SUBJECT: Savannah River Site's Responses to the Regulatory Comments on the 2018 Annual Comprehensive TNX Area Groundwater Monitoring and Remedial Action Effectiveness Interim Report (U) (SRNS-RP-2019-00391, Revision 0, June 2019) SEMS Numbers: 21, 29

**SRS Responses to EPA Comments on the
2018 Annual Comprehensive TNX Area Groundwater Monitoring and Remedial Action
Effectiveness Interim Report (U), SEMS Number 21, 29, SRNS-RP-2019-00391, Revision 0, Dated
June 2019, Savannah River Site, Aiken, South Carolina**

**SRS Responses to SCDHEC Comments on the
2018 Annual Comprehensive TNX Area Groundwater Monitoring and Remedial Action
Effectiveness Interim Report (U), SEMS Number 21, 29, SRNS-RP-2019-00391, Revision 0,
Dated June 2019, Savannah River Site, Aiken, South Carolina**

Attachment 1. Time Series Plot of Combined Radium and Gross Alpha Concentrations at TBG 3.

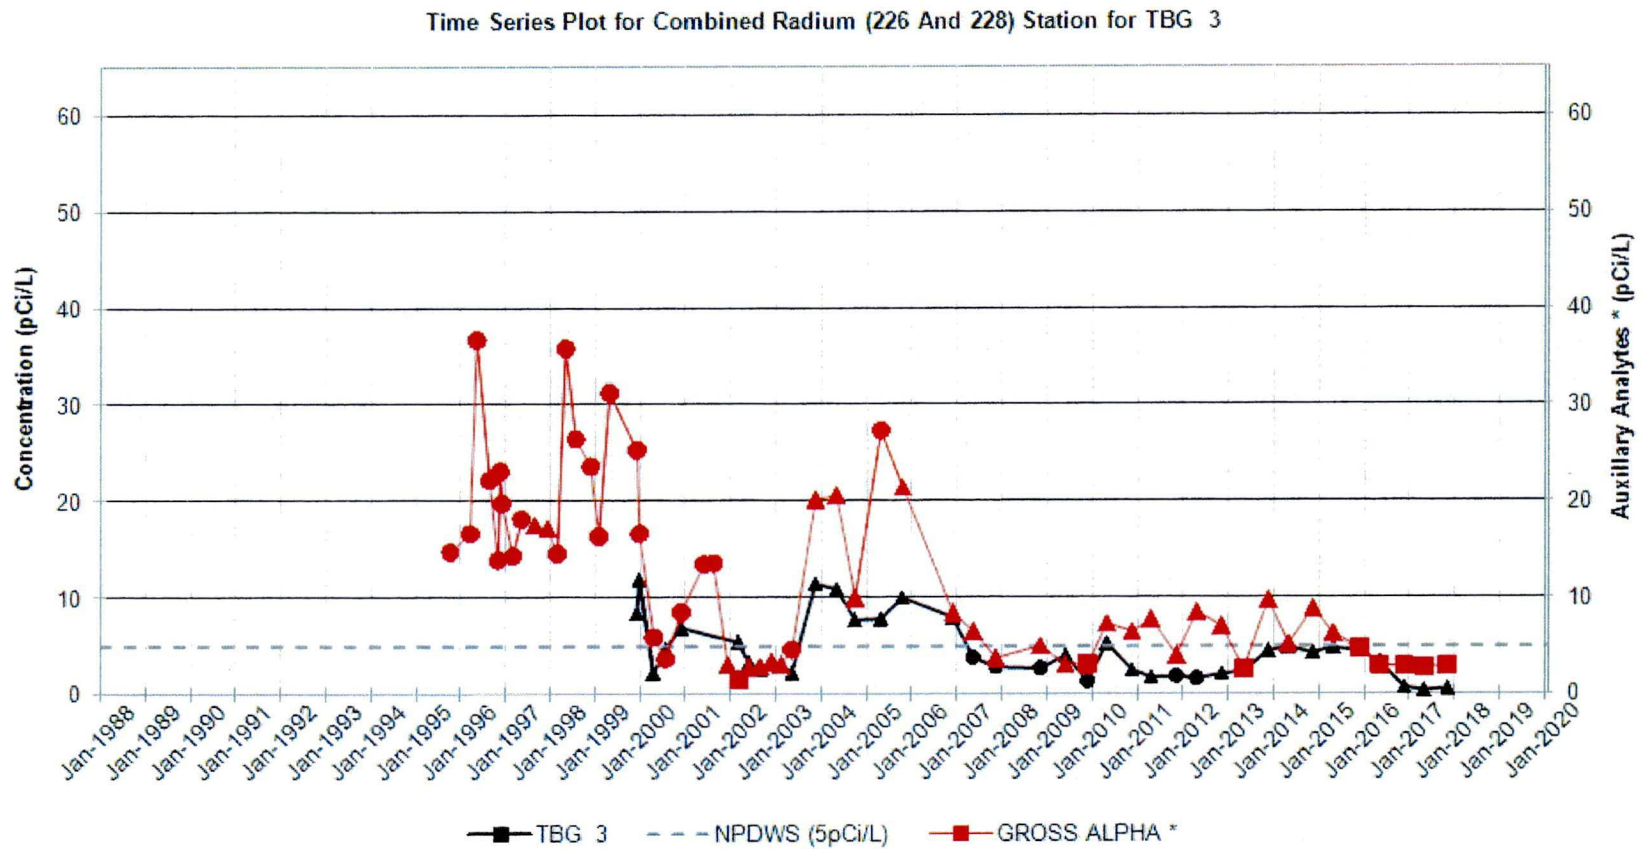
13. The text in the last paragraph of Section 6.5 Combined Radium, Uranium, Gross Alpha and Adjusted Gross Alpha, Page 38 of 54, states, “At TBG 3, gross alpha and combined radium exceedances appear to be directly related. At TBG 4, the gross alpha concentrations appear to correlate with combined radium concentrations before 2010 and correlate to uranium concentrations after 2010.” References to data to support this comparison are not provided. It is noted that time series graphs with both gross alpha and the related radionuclide would better support the analysis. Revise the 2018 Annual Report to address this issue.

Response: Agree with Clarification. Future annual reports will include and provide a reference to time series graphs to support these statements. The time series graphs for TBG3 and TBG4 are provided in Attachments 1 and 2 to the comment responses. No change to the document is proposed.
